NOTICE OF DECISION

HISTORIC DESIGN REVIEW CASE NO.: HIS18-12

SUMMARY: A proposal to install new awnings and HVAC mechanical equipment on the Gray Building (c.1891).

PHASE 2
THE GRAY BUILDING
State Street & Liberty Street SE, Salem, Oregon 97301

ROOF PLANS

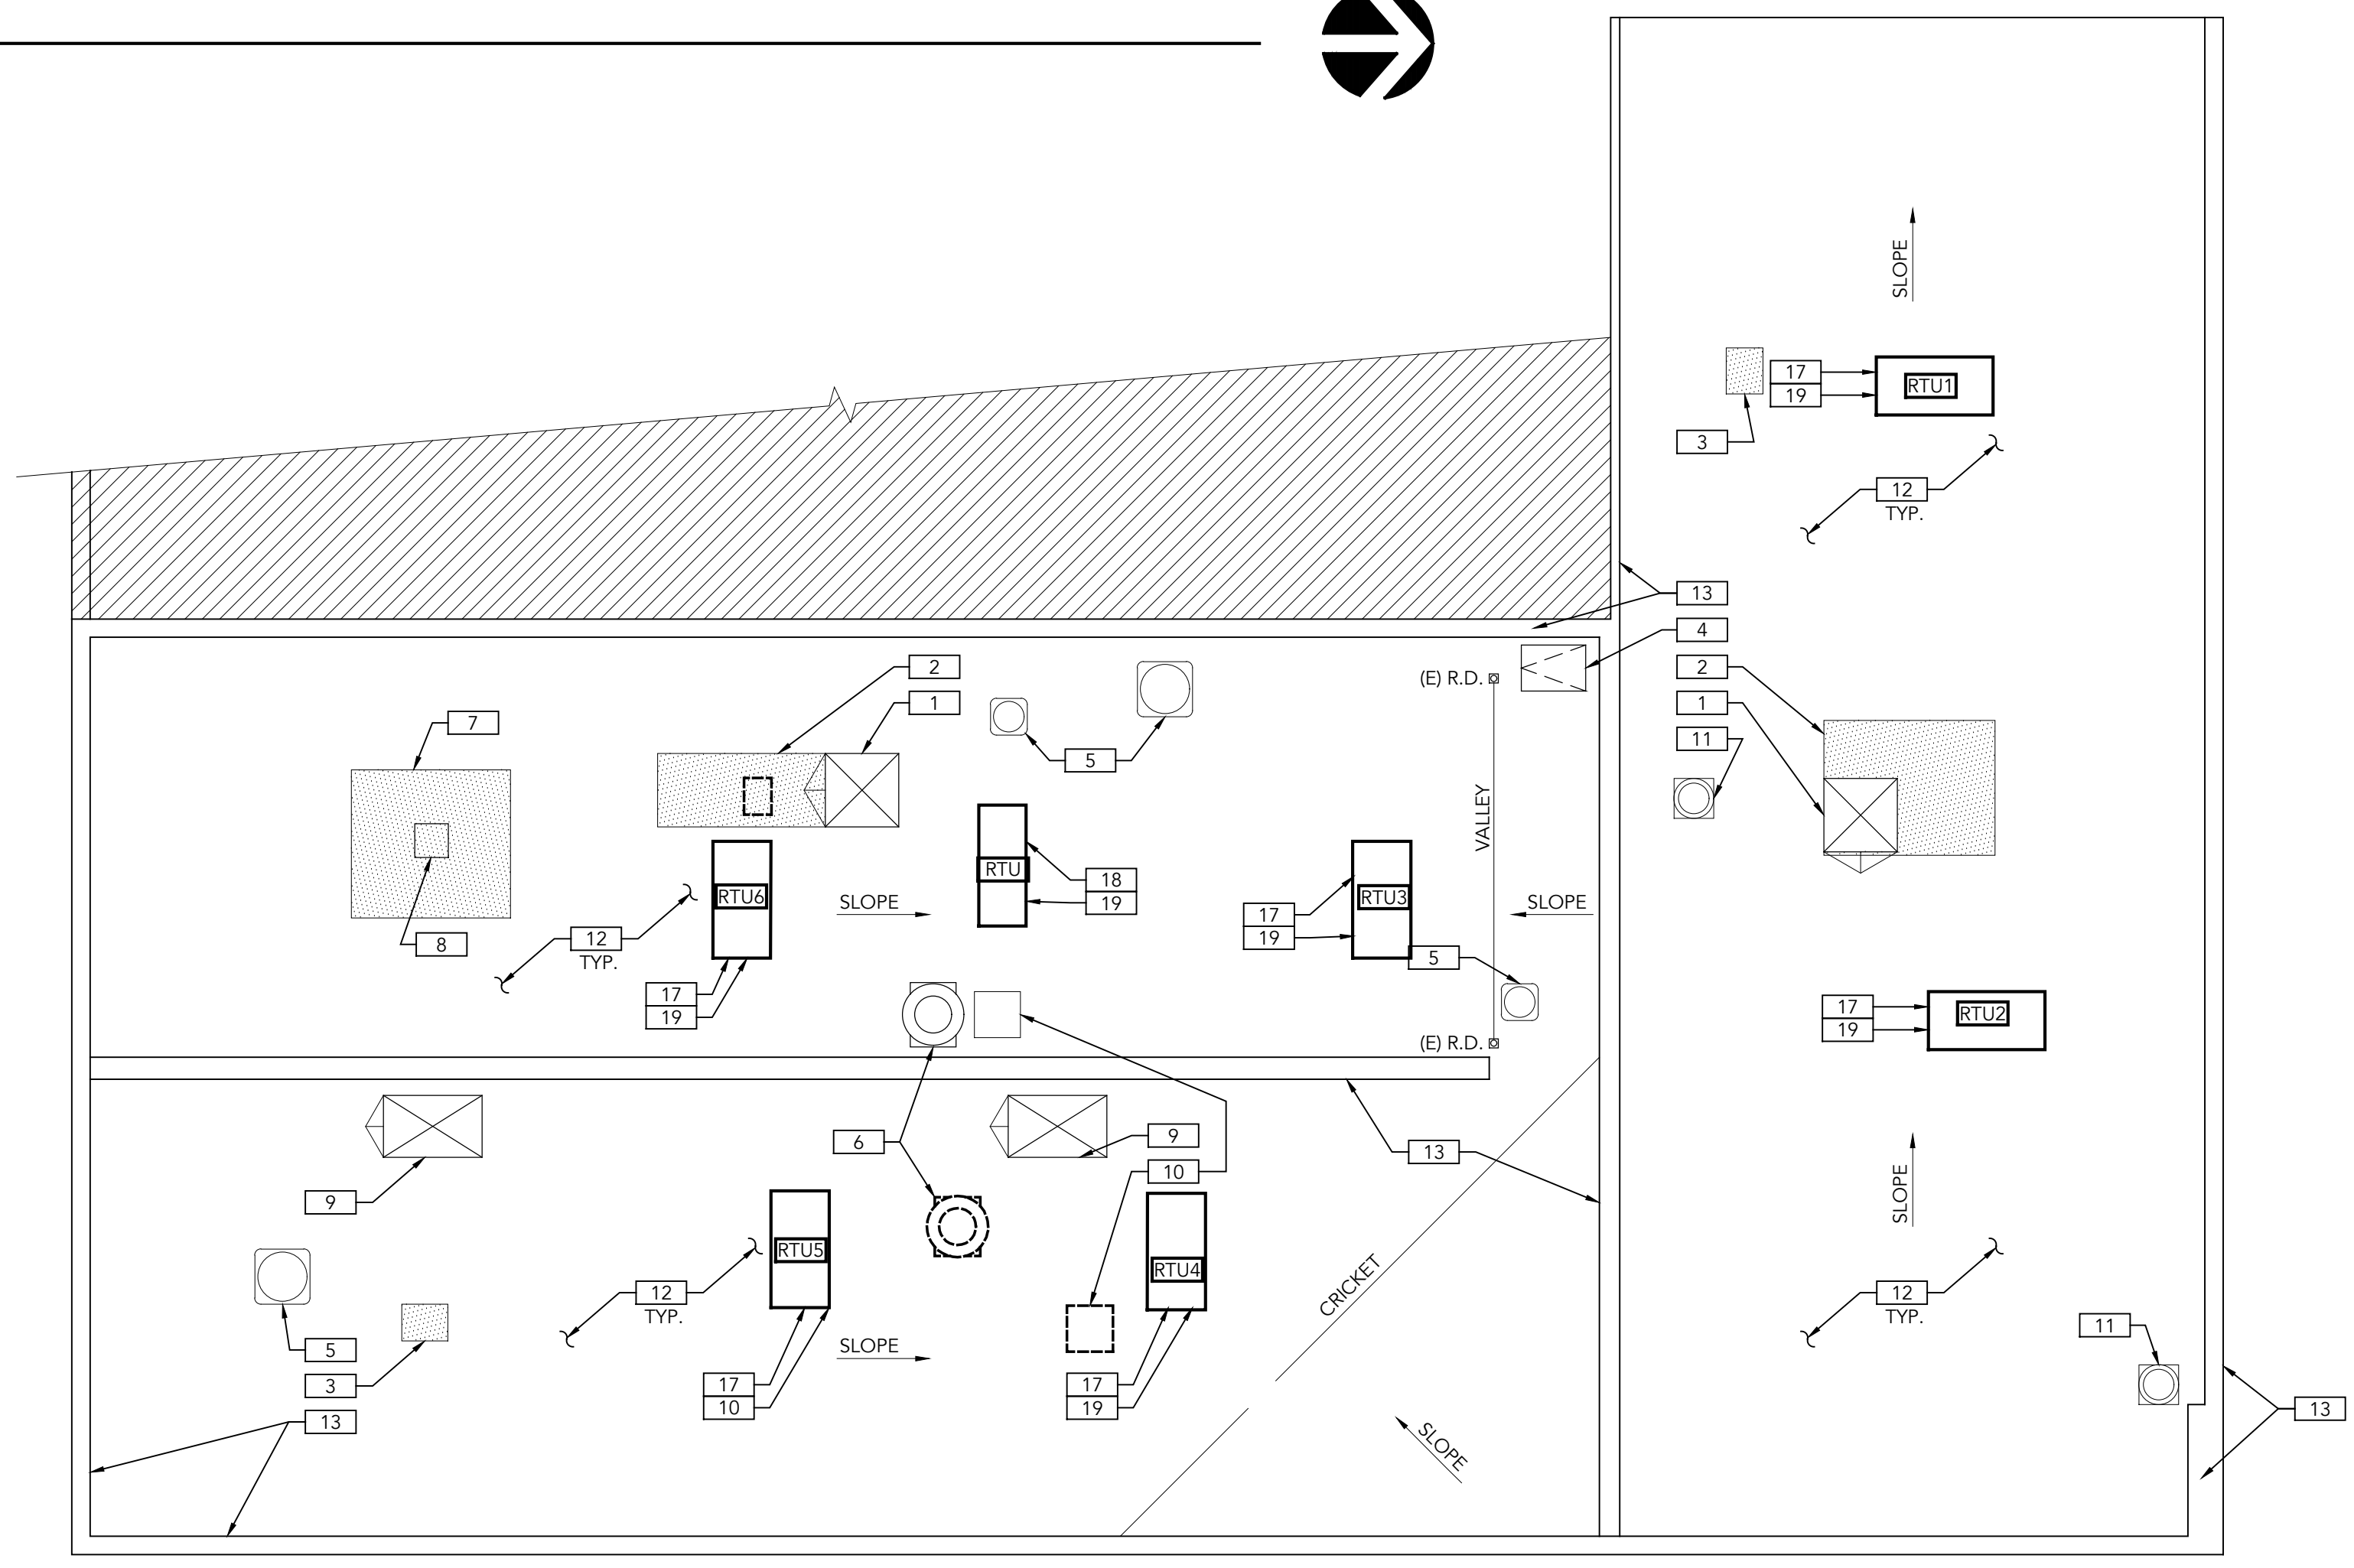
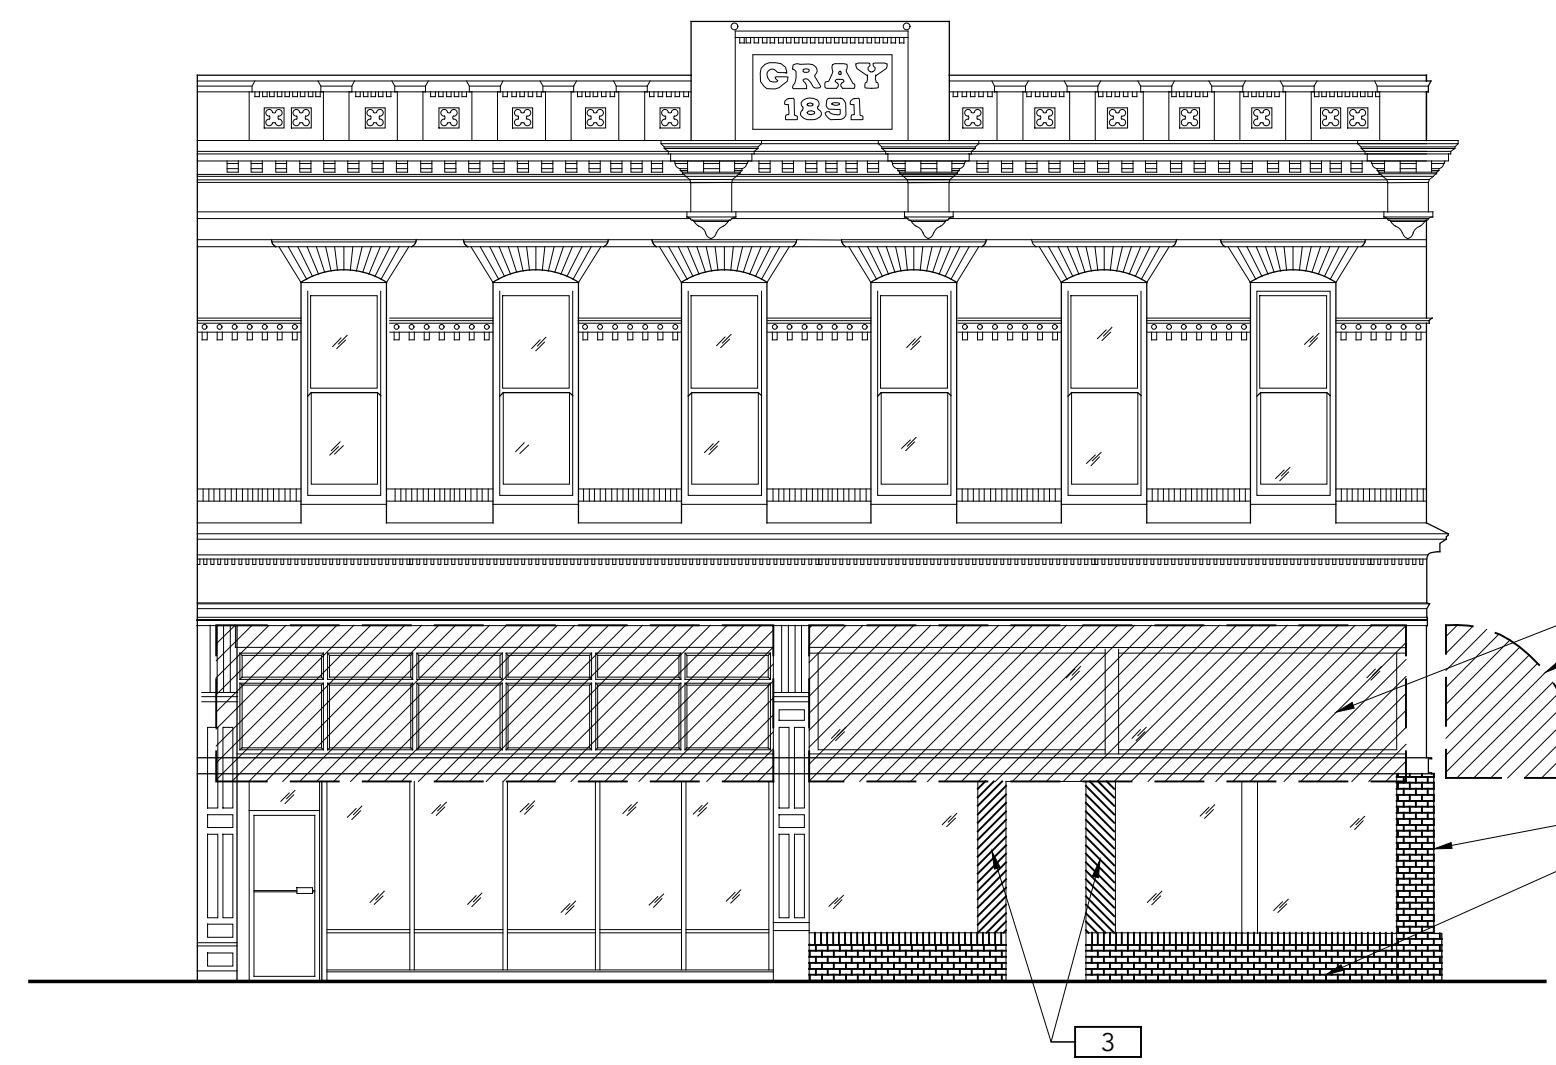
The proposed new HVAC equipment is located on the roof, set back from the parapet, and not easily visible, thereby meeting SRC 230.040(j)(2)(A).

The proposed new HVAC equipment will be placed on the roof of the Gray Building, recessed behind the parapet, thereby meeting SRC 230.040(j)(2)(B).

The proposed new HVAC equipment is placed on the roof of the Gray Building, set back and screened by the parapet, not easily visible from the right of way, thereby meeting SRC 230.040(j)(2)(C).

EXTERIOR ELEVATIONS

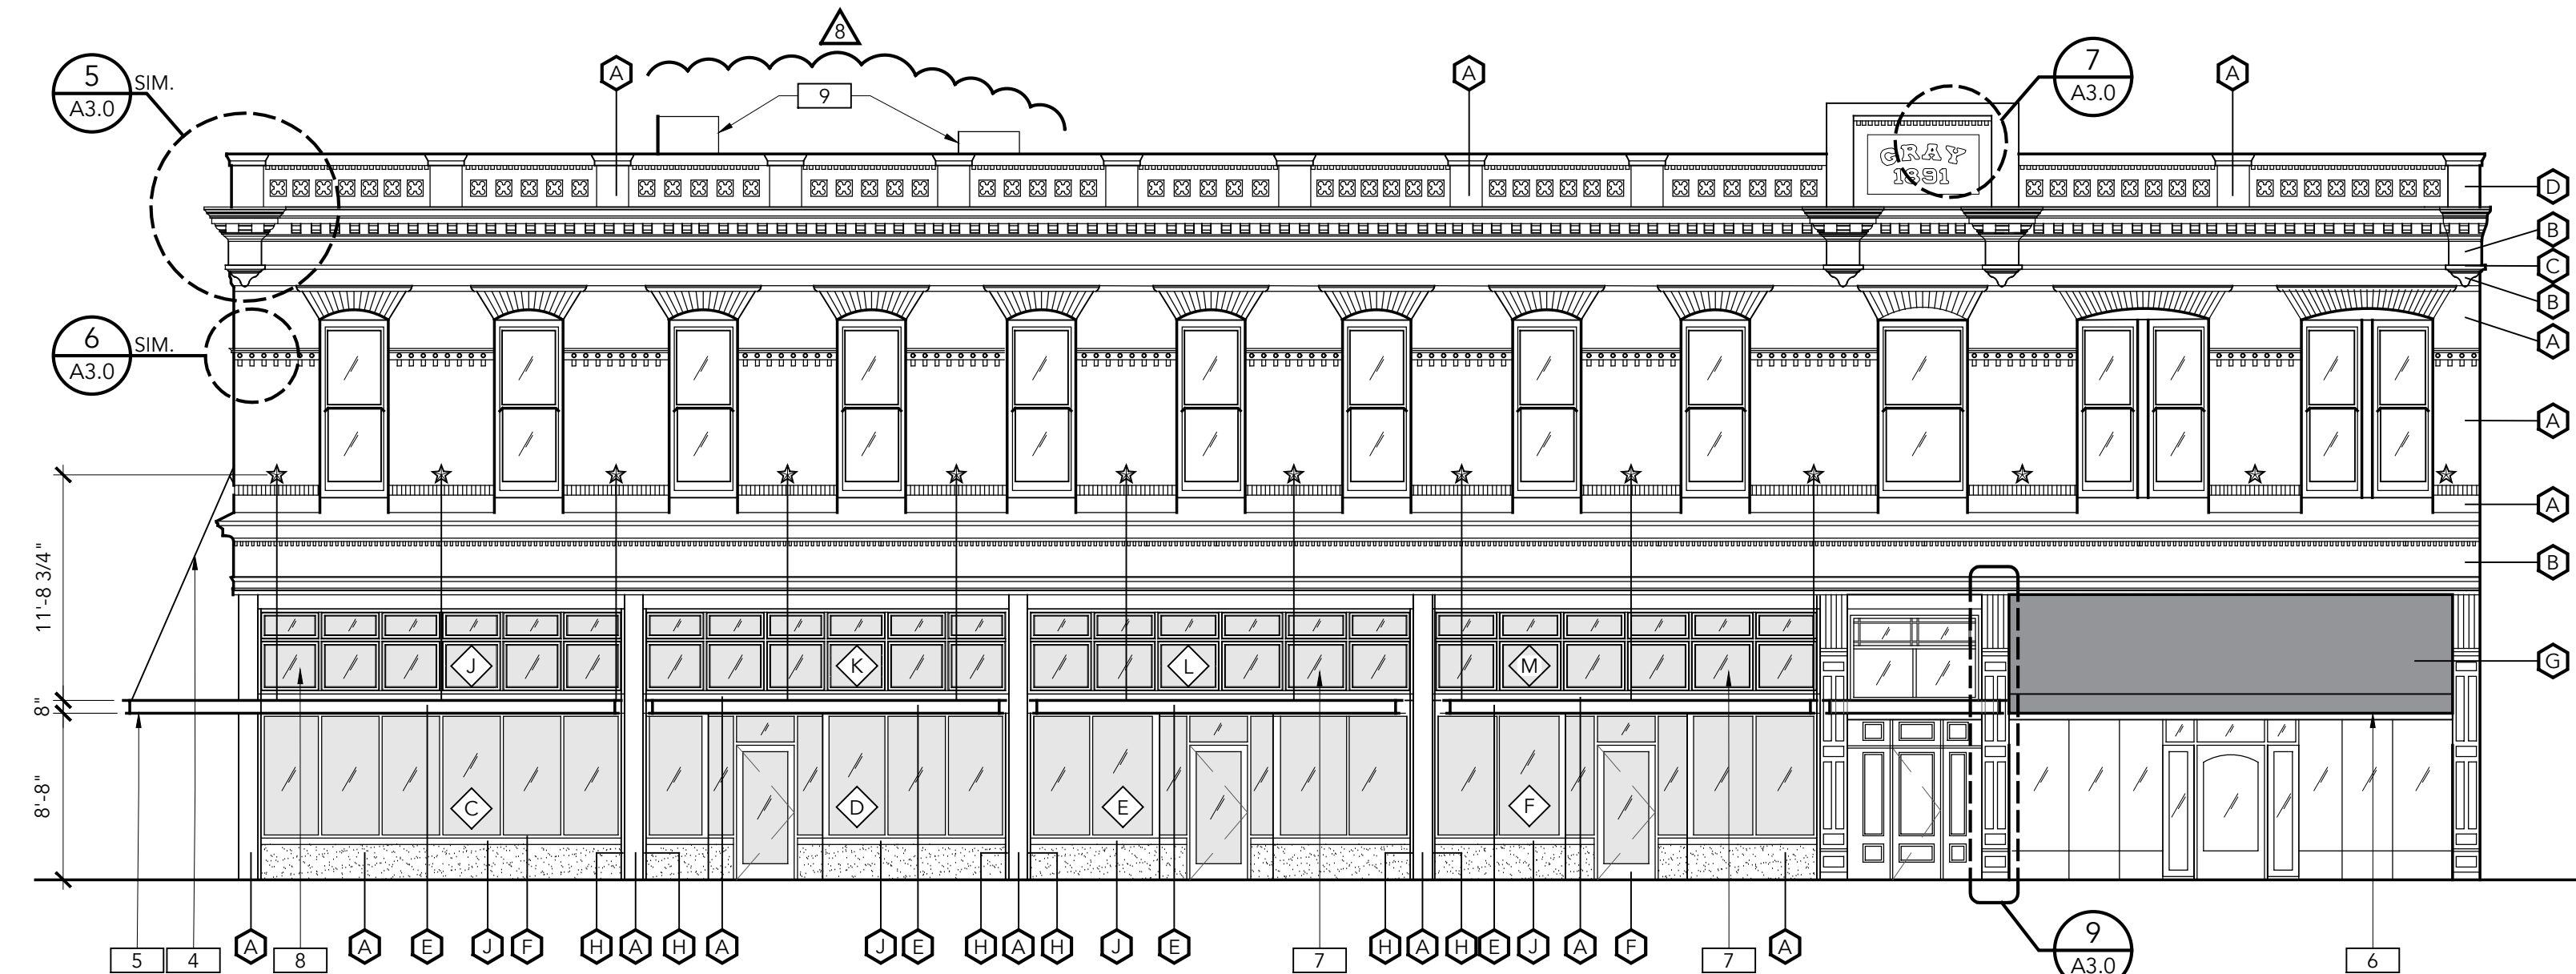
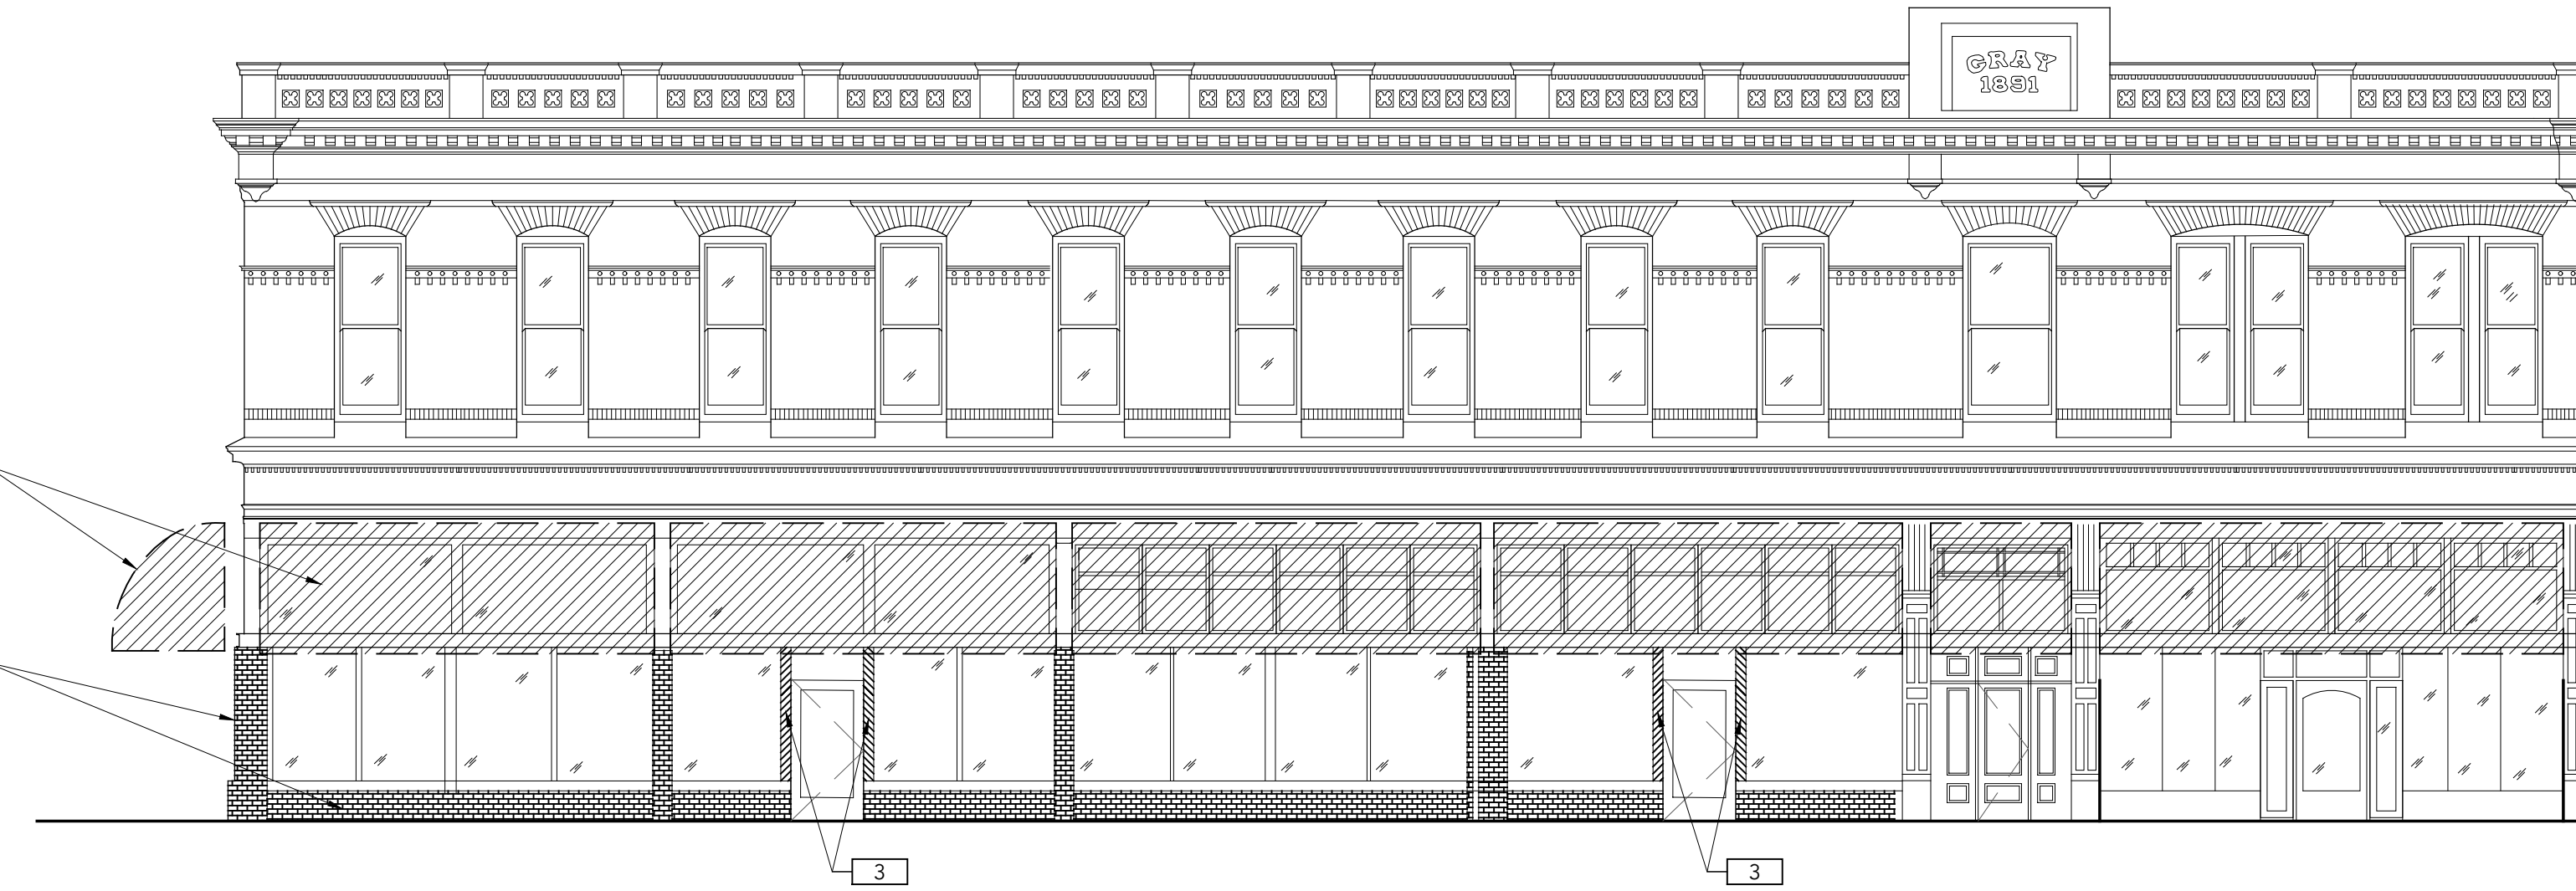
The proposed new metal canopies and fabric awning are located within window openings and within the transom opening, thereby meeting SRC 230.040(k)(2)(A).

The proposed new canopies will be attached to the building by metal cables and affixed to the wall by a threaded rod welded to a ¼" plate covered with a decorative star cover plate. The new fabric awning will be stretched over a metal canopy frame affixed to the front of the building with bolts, thereby meeting SRC 230.040(k)(2)(C).

The proposed new canopies and awning does not obscure significant architectural features of the Gray Building, thereby meeting SRC 230.040(k)(2)(E).

Thank you for opportunity to provide courtesy comments on the Gray Building in downtown Salem that is currently taking advantage of the Special Assessment Property Tax Program and the Federal Historic Tax Credit. All this work appears to meet the Standards and recommended for approval. While the new proposed HVAC is proposed for placement on the roof, they have been pushed back as far as possible from the parapet as to not be readily visible from the public right-of-way even though they appear visible (approximately 6 inches to a foot) in the two dimensional elevation drawings.
